Public Input No. 196 assigned to Code-Making Panel 4, Refer to Code-Making Panel 15

Public Input No. 196-NFPA 70-2023 [Definitions (100): Microgrid... to Microgrid

<u>File Name</u>	<u>Description</u>	<u>Approved</u>
IMG_2424.jpg	Figure 517.2 Health Care Electrical Sources and Distribution Systems

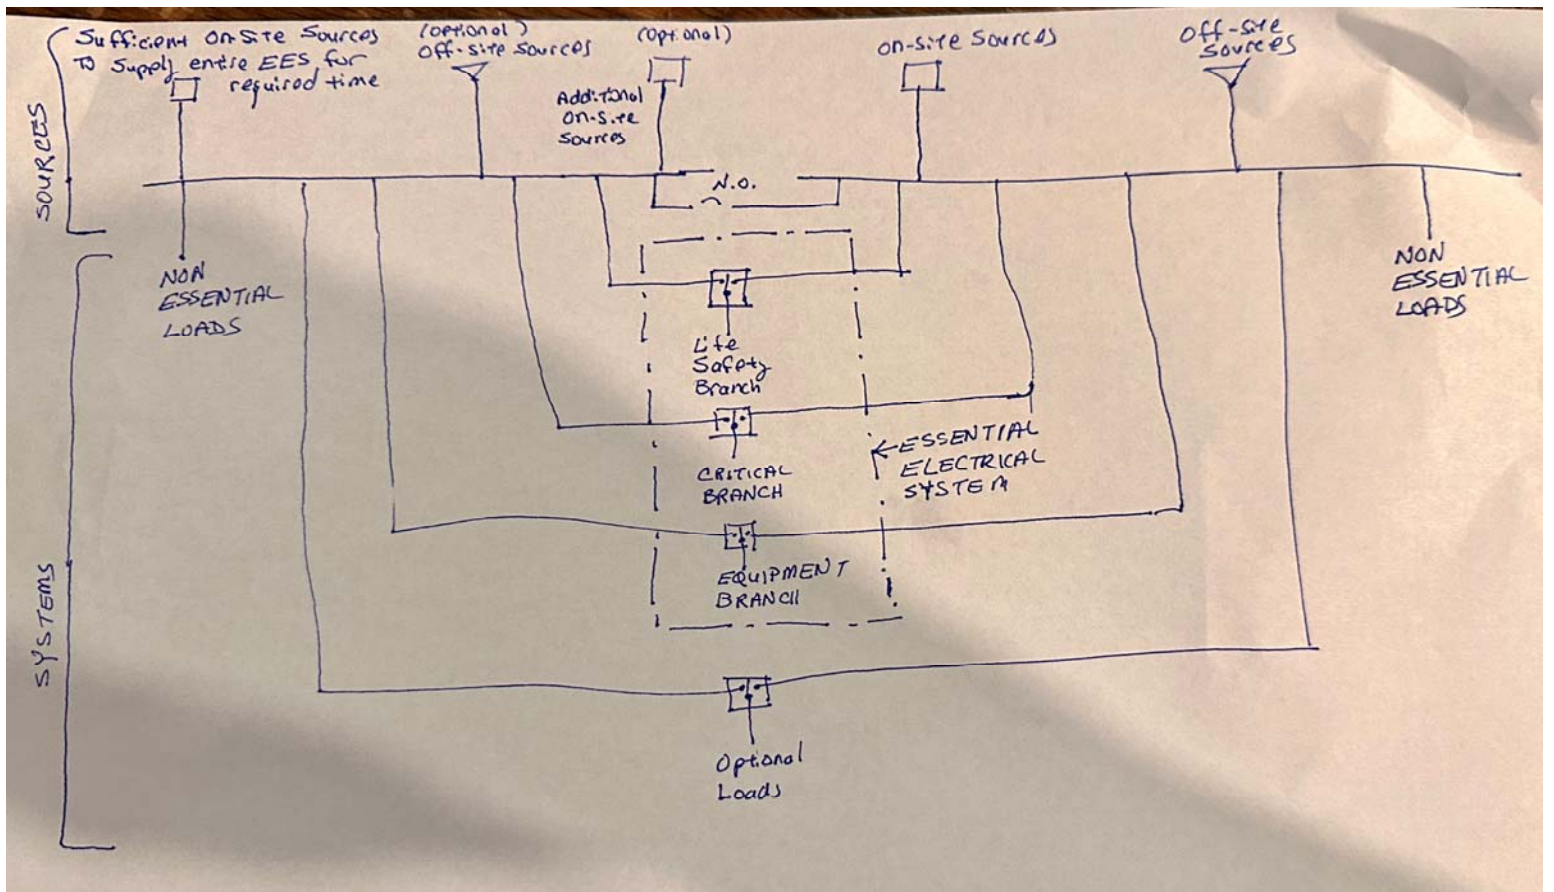
The sizing requirements of service and feeders is included in Article 220, however the concept of utilizing on-site power resources (Sources and stored energy power supply systems) appears to be a newer concept that has not been addressed directly by code. This statement clarifies the minimum requirements for the resources that feed the entire site. Related sections 517.30(A) and 517.41(A) provide minimum requirements for the sizing of resources that feed the Essential Electrical System. We recommend that this new language be added to ensure that adequate resources are provided for both the entire site electrical requirements and for the Essential Electrical System as required in 517.3(A) and 517.41(A) for the Essential Electrical System.
